Access Compliance Report

Public Rights-of-Way

(Curb Ramps)

Intersection ID: 43374	Main Street: COOPER'S RIDGE LN	Cross Street: BERNBROOKE_SHADOW LN	Location: W
ADA ID: 5A3A7B1767BD	Ramp Type: BlendTrans1	Initial Pass/Fail: Fail	Overall Compliance: No
Severity Score: 21.25			
Codes/Mitigation Info/Possible Solution		Field Measurements/Component Compliance

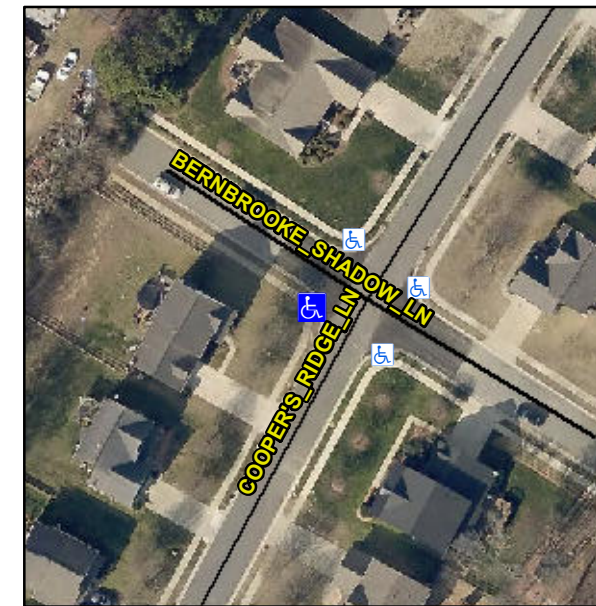
Not Found, R304.5.1, R304.5.3

Compliance	Description	Data	Compliance	Description	Data
N/A	Ramp Length (in)	47.5	Yes	BlendTrans Slope (%)	3.1
No	Ramp Width (in)	37.0	No	BlendTrans XSlope (%)	5.6
N/A	Flare Type LT	N/A	N/A	Flare Type RT	N/A
N/A	Flare Slope LT (%)	N/A	N/A	Flare Slope RT (%)	N/A
N/A	Flare Traversable LT?	N/A	N/A	Flare Traversable RT?	N/A
N/A	Landing Length (in)	N/A	N/A	DWS Provided?	N/A
N/A	Landing Width (in)	N/A	N/A	DWS Contrast?	N/A
N/A	Landing Slope (%)	N/A	N/A	DWS Length (in)	N/A
N/A	Landing X Slope (%)	N/A	N/A	DWS Full Width?	N/A
N/A	Landing Curb? (Y/N)	N/A	N/A	DWS Offset (in)	N/A
N/A	Shared Landing?	N/A			
N/A	Gutter Ponding?	N/A	N/A	Gutter Slope (%)	N/A
N/A	Gutter Lip Ht (in)	1.0	N/A	Gutter X Slope (%)	N/A
N/A	Painted X Walk1?	No	N/A	Painted X Walk2?	No
	X Walk 1 Direction	To SE		X Walk 2 Direction	To NE
	X Walk 1 Width (in)	N/A		X Walk 2 Width (in)	N/A
	X Walk 1 Slope (%)	1.6		X Walk 2 Slope (%)	2.8
	X Walk 1 X Slope (%)	1.0		X Walk 2 X Slope (%)	2.7

N/A	Ramp inside XWalk1?	N/A	N/A	Ramp inside XWalk2?	N/A
	Road Slope (%)	2.9		Clear Space?	N/A
	Road X Slope (%)	1.3	N/A	Clear Space to XWalk (in)	N/A
N/A	Any Obstructions?	N/A	N/A	Storm Grate/Utility Hazard?	N/A
	Obstruction Type			Storm Grate/Utility Type	
		N/A			N/A
			Yes	Surface Condition? (G/P)	Good
			No	Curb Slope (%)	12.5

Remove & Replace Curb Ramp With Two New Directional Ramps or Equivalent.
